# Access Compliance Report

## Public Rights-of-Way

Intersection ID: 48947	Main Street: DAVID_JENNINGS_AV	Cross Street: PEPPERPIKE_WY	Location: NE
ADA ID: 66DE78B4222C	Ramp Type: Perp	Initial Pass/Fail: Fail	Overall Compliance: No
Severity Score: 22.5			
Codes/Mitigation Info/Possible Solution		Field Measurements/Component Compliance

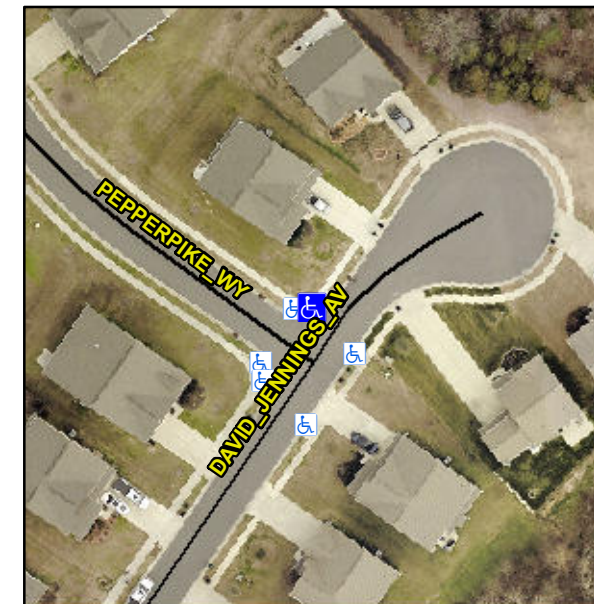
**Not Found, R304.5.1, R304.2.2, R304.5.3**

Compliance	Description	Data	Compliance	Description	Data
N/A	Ramp Length (in)	48.5	No	Ramp Slope (%)	10.5
No	Ramp Width (in)	47.5	No	Ramp XSlope (%)	2.6
N/A	Flare Type LT	N/A	N/A	Flare Type RT	N/A
N/A	Flare Slope LT (%)	N/A	N/A	Flare Slope RT (%)	N/A
N/A	Flare Traversable LT?	N/A	N/A	Flare Traversable RT?	N/A
N/A	Landing Length (in)	N/A	N/A	DWS Provided?	N/A
N/A	Landing Width (in)	N/A	N/A	DWS Contrast?	N/A
N/A	Landing Slope (%)	N/A	N/A	DWS Length (in)	N/A
N/A	Landing X Slope (%)	N/A	N/A	DWS Full Width?	N/A
N/A	Landing Curb? (Y/N)	N/A	N/A	DWS Offset (in)	N/A
N/A	Shared Landing?	N/A			
N/A	Gutter Ponding?	N/A	N/A	Gutter Slope (%)	N/A
N/A	Gutter Lip Ht (in)	N/A	N/A	Gutter X Slope (%)	N/A
N/A	Painted X Walk1?	No	N/A	Painted X Walk2?	N/A
	X Walk 1 Direction	To SE		X Walk 2 Direction	N/A
N/A	X Walk 1 Width (in)	N/A	N/A	X Walk 2 Width (in)	N/A
	X Walk 1 Slope (%)	0.7		X Walk 2 Slope (%)	N/A
	X Walk 1 X Slope (%)	1.6		X Walk 2 X Slope (%)	N/A

**Remove & Replace Entire Ramp.**
